**MISSAN SURGICAL HOSPITAL**  
**UNDER THE ECONOMIC SUPPORT FUND**  
**AL AMARAH, IRAQ**

**SIGIR PA-08-165**  
**SIGIR PA-08-167**

## Missan Surgical Hospital

### Summary of Report: PA-08-165 and PA-08-167

Figure 6. Storm water pump station plan

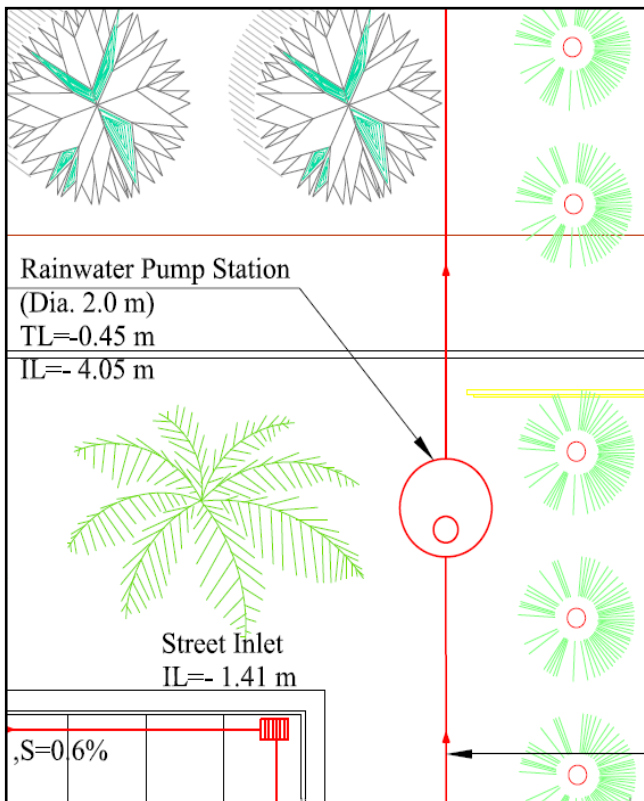
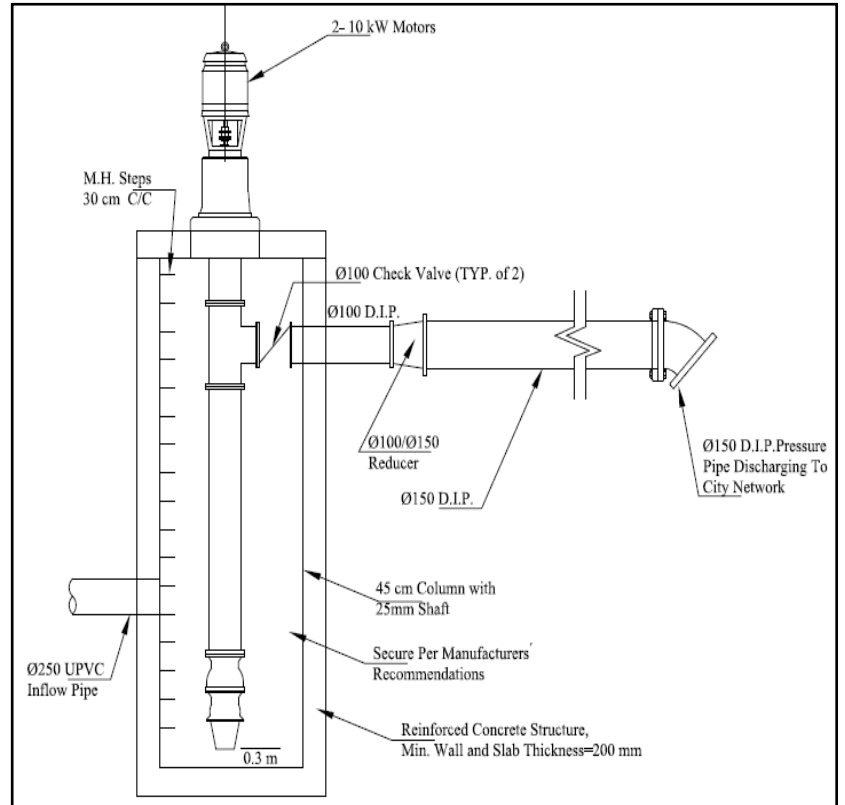
The contractor's plans lacked adequate information for SIGIR to determine how the pumps are controlled or how they will address low-flow conditions. SIGIR is concerned that the high capacity of the pumps combined with the small size of the wet well may result in a rapid cycling of the pumps leading to overheating and premature pump failure.

**Figure 8. Perimeter retaining wall section**

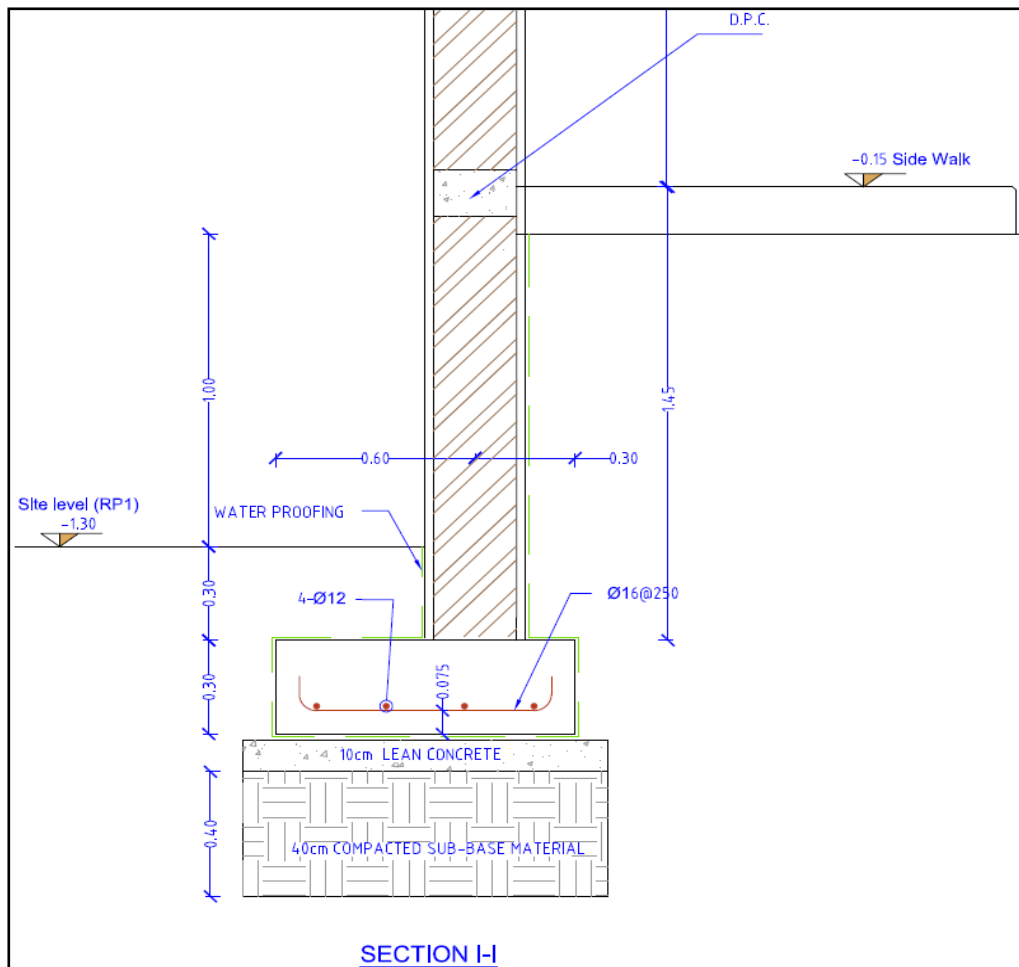
The contractor's design plan detailed the perimeter fence along the north edge of the project site. The plan indicated the application of waterproofing to the portion of the wall below grade (Figure 8). However, the application of waterproofing without the integration of subsurface drainage behind the wall may allow for the buildup of hydrostatic pressure against the wall and possible localized failure of the brick infill.

In addition, the external security fence design did not include any concertina or barbed wire at the top. With only two guard houses (one at each opening to the hospital) and a wall that is only 2m high, concertina wire maybe needed to better secure the facility.

**Figure 9. Location of the two guard houses for the MSH (Courtesy of GRS)**

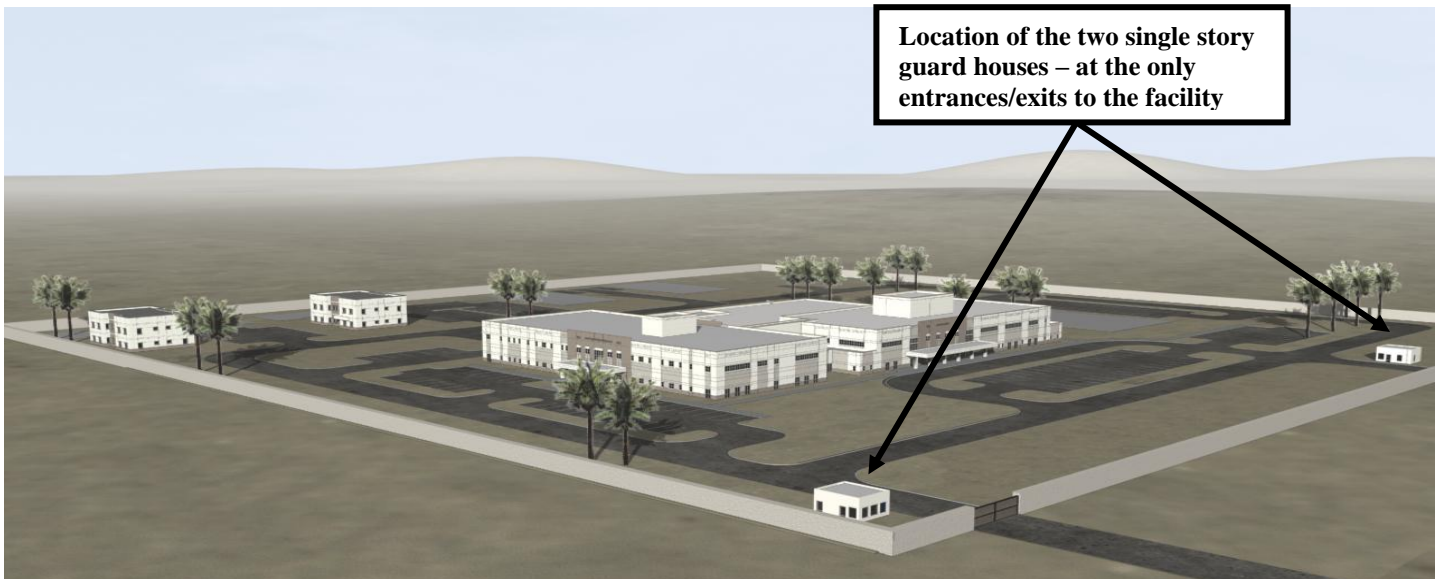
In addition, both the U.S. government and contractor's designs called for only two guard houses (one at each entrance/exit to the hospital – Figure 9). The single-story guard houses provide hospital security by checking people and vehicles as they enter the facility. However, since the guard towers are not elevated and the perimeter security wall is 2m high, the guards will have no ability to monitor any area of the facility outside of the entrances/exits. Consequently, this leaves the perimeter of the hospital site vulnerable to attack. Considering the overall size of the project site is 62,500 m<sup>2</sup> and the main hospital buildings obstruct a significant portion of the view

from the guard house, additional guard houses and elevated guard towers are necessary to provide adequate security.

Figure 10. Contractor’s river intake detail design (Courtesy of GRS)

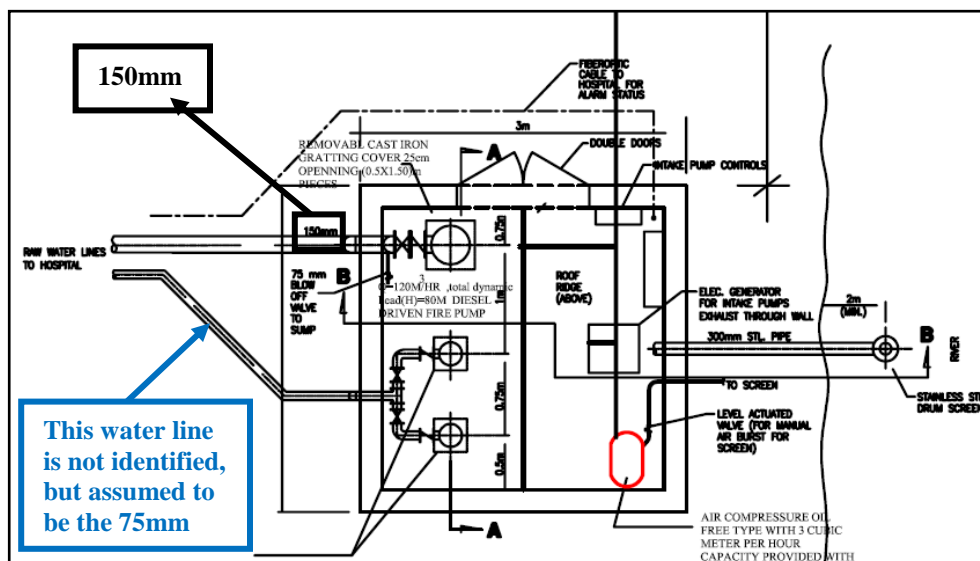
In addition, GRS provided two designs drawings for the raw water intake; both designs dated 30 April 2008. These designs, dated 8 months prior to SIGIR’s site visit, were not part of the original project file documentation provided to SIGIR; instead GRS provided these drawings after the exit conference. After reviewing both designs, SIGIR determined them to be, at best, conceptual designs because they lacked specific details on piping elevations and lengths, electrical systems designs, access roads, flooding levels, and grading requirements.

Further, when placed together, the two designs clearly show a lack of detail and cohesion. For example, the SOW required two water lines – one for water processing and one for fire suppression. The “River Intake 6-5 River Intake (1)” design identified only the 150 mm water line; while the “site-maissan Water(27) WATER FIRE(27)(1)” design only identified the 75 mm water line (Figures 10-12). Also, since the security wall has already been constructed, the contractor will now have to excavate under it in order to route the water lines under the wall. In addition, the exact location of the river intake has yet to be determined; instead GRS AAO stated it will be “located approximately where the Tigris [River] and Al Kahla [River] intersect.”

Figure 11. Contractor's water site plan (Courtesy of GRS)

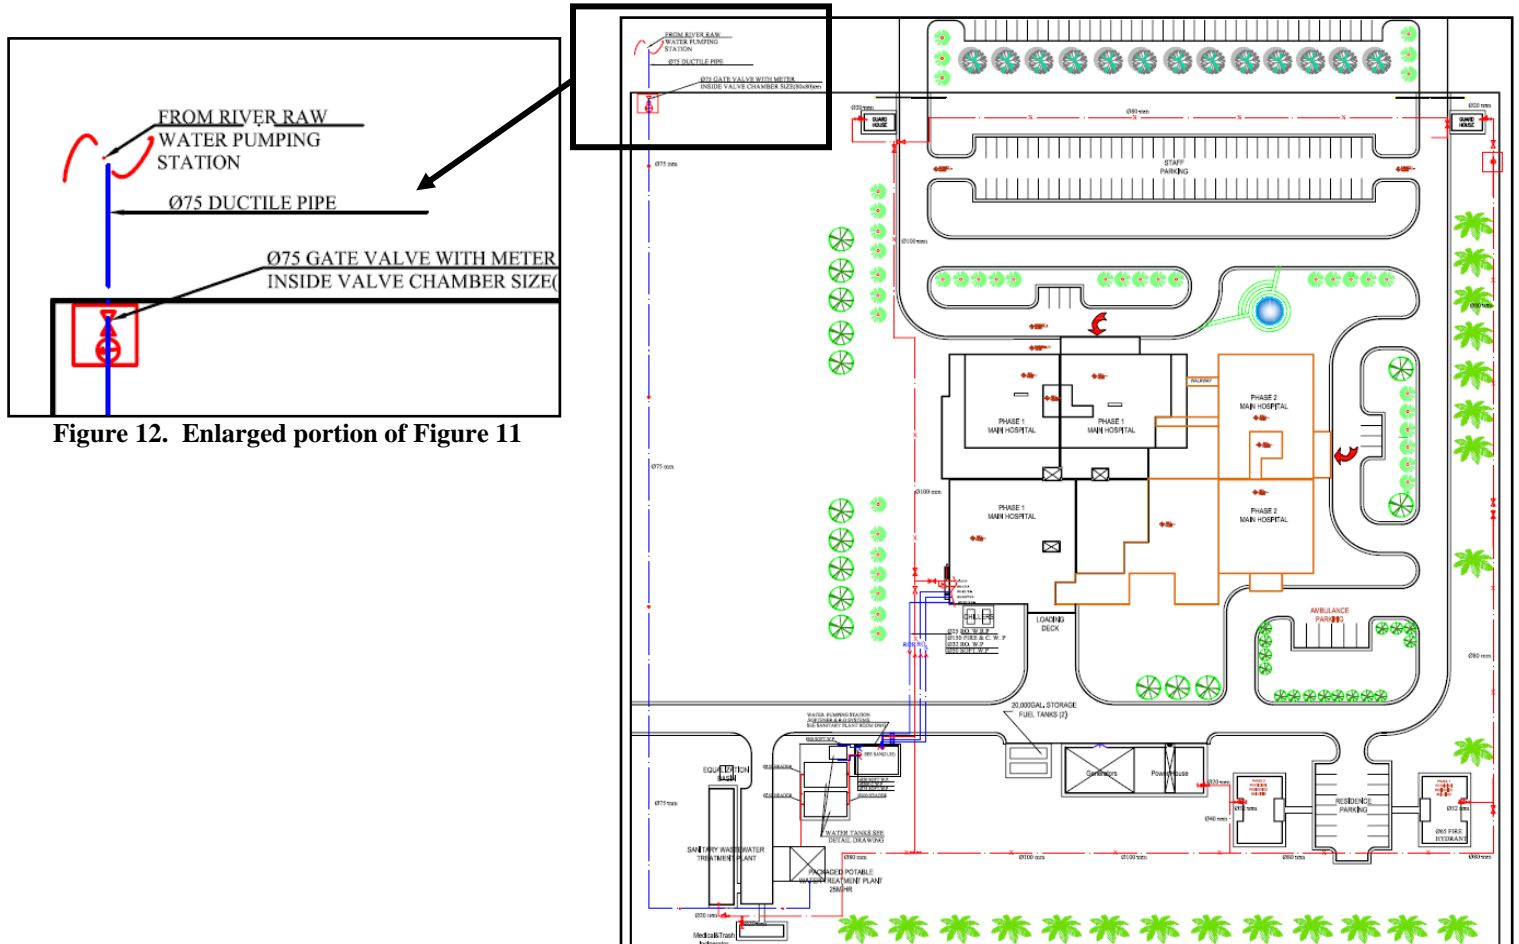
In April 2009, SIGIR brought these deficiencies to GRS AAO’s attention. Specifically, the latest version of design drawings GRS provided SIGIR were not detailed, omitted significant information, and were not complete.

Figure 14. Contractor’s overall wastewater treatment plant schematic drawing (Courtesy of GRS)

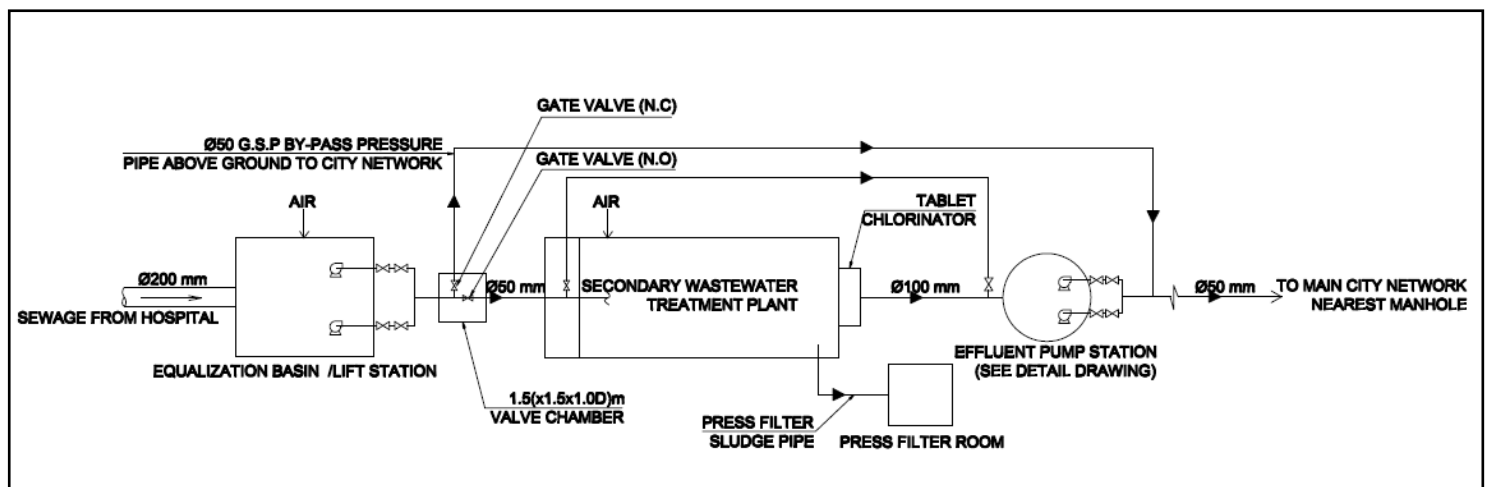
Similar to the water supply system, the wastewater system design lacked significant details, such as the alignment and outfall of the sewage leaving the hospital site. Figure 14 shows the overall wastewater treatment plant schematic drawing, which indicates that the sewage leaving the hospital will be deposited directly into the “main city network nearest manhole” without identifying the exact location and distance to the nearest manhole, the size, elevation, and condition of the main city network sewer pipe, and whether or not an analysis has been performed to determine if the existing city network system can accommodate the significant additional flow the hospital will provide. To ensure that sewage does not back up into the hospital or in nearby neighborhoods, it is important that the network have the capacity to handle the additional flow.

**Figure 17. Comparison of typical design column section versus column as constructed**

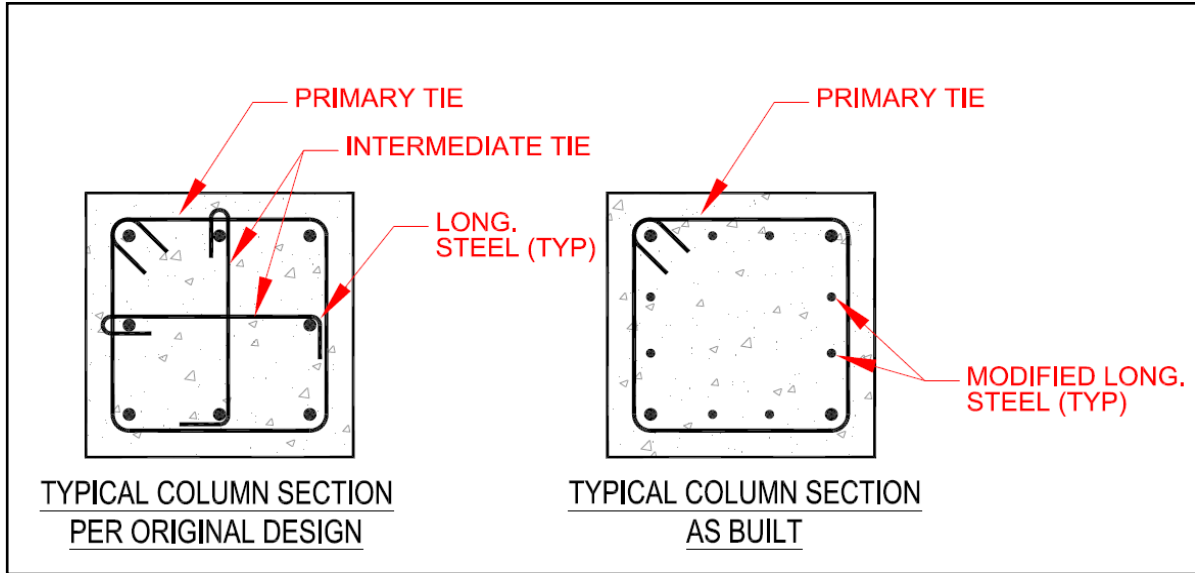
In addition, SIGIR noted that the reinforcing configuration used in the construction of the reinforced concrete columns varied from the configuration specified in the design drawings. Figure 17 clearly illustrates the difference between the design drawing and actual construction of the reinforcing configuration. The design drawing required three separate pieces of reinforcement bar along with two ties (primary and intermediate). The primary ties a steel bar around the perimeter of the vertical reinforcement bars; while the intermediate ties a steel bar from the middle reinforcement bar of one side to the other. However, the contractor opted to use four vertical pieces of reinforcement bar along with a primary tie around the perimeter.

In order to more clearly illustrate the difference in the design versus actual construction, Figure 17 is the reinforcement configuration from the design drawings; while Figure 17 and Site Photo 5 document the actual construction performed by the contractor.

Since the contractor did not construct the reinforcing configuration according to its own design drawings, SIGIR reviewed the project file for the necessary waiver. The project file lacked any documentation indicating tests and/or structural analysis of the columns had been performed to qualify for a waiver from the use of lateral reinforcing of the columns.
